FARRAGUT VISUAL RESOURCES REVIEW BOARD AGENDA

Tuesday, January 26, 2021
7:00 p.m.

a) Existing Commercial Site (formerly Blockbuster Video) - 11135 Kingston Pike

This item involves a revised landscape plan for the former Blockbuster Video commercial center located at 11135 Kingston Pike. The applicant is proposing to remove and replace a number of the trees in the development in accordance with the new plan. The proposed plan covers the main parking lot and portions of the side yards. No work is proposed behind the buildings.

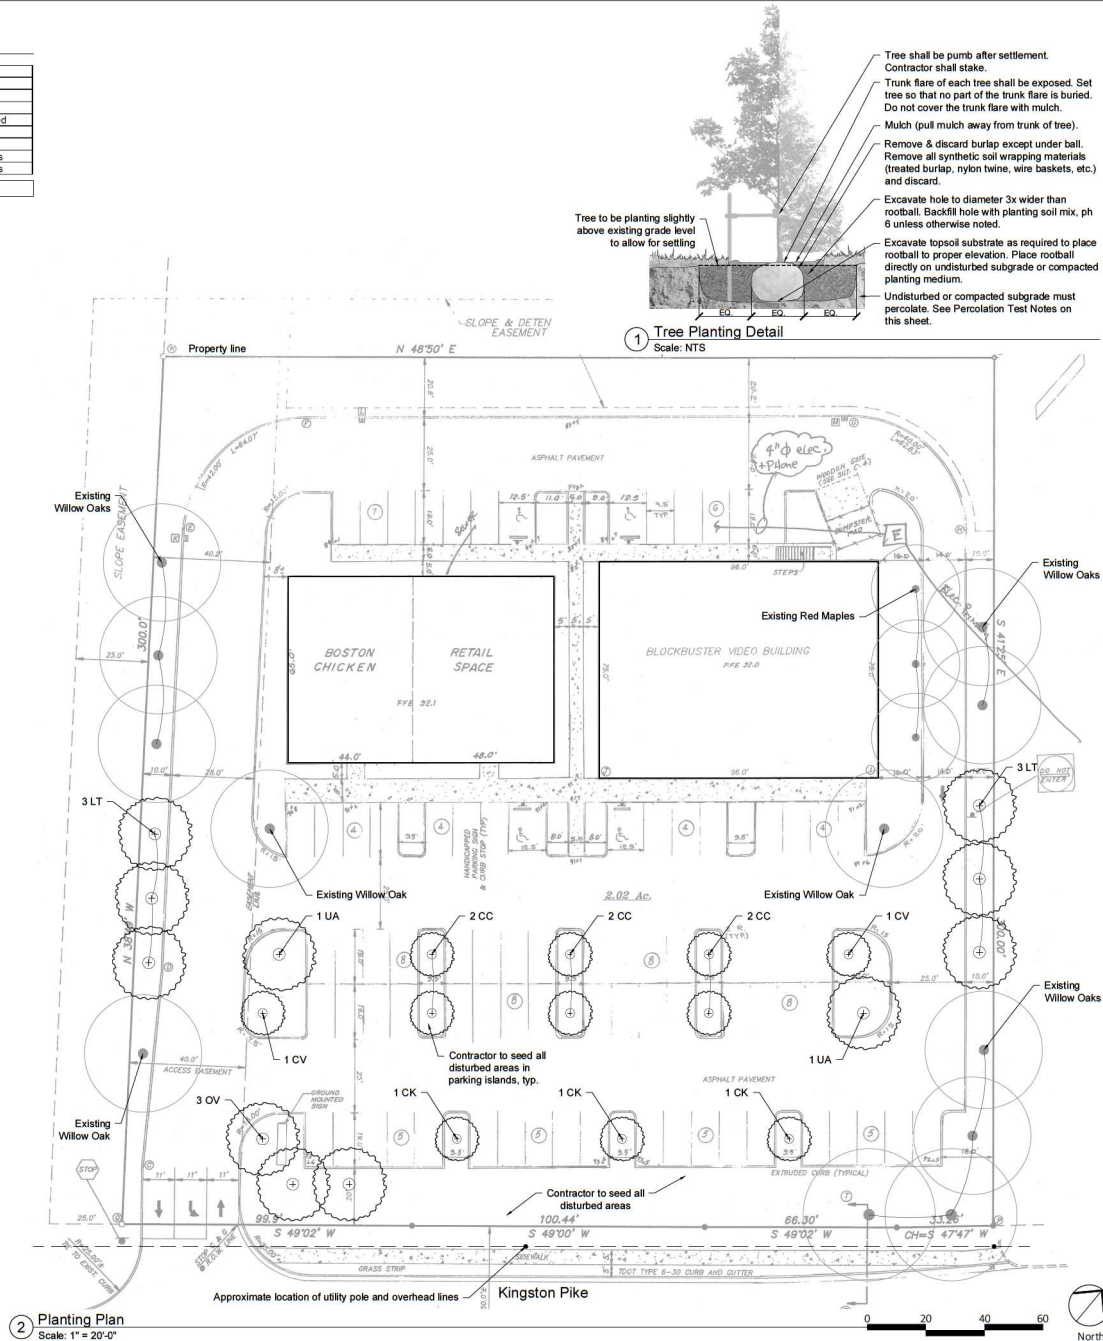
1. Please correct the plan and all calculations to clearly meet/reflect the one shade tree per 2500 square feet of improvements on a total lot coverage basis. The current plan seems to have incorrectly applied to the standard only to the parking lot area;
2. Eastern Hop Hornbeam is not listed as a qualifying shade tree on the Town's recommended tree list and cannot be used to satisfy the shade tree requirements. Please correct the Plant Key Table accordingly;
3. Please modify Planting Note 11 to indicate that any/all plant substitutions require Town staff approval;
4. KGIS lists the main address for the parcel as 11135 Kingston Pike. Please update the address shown in the plans title block; and
5. Please clarify/note that no trees are being removed and no changes are being made at the rear of the site behind the buildings.
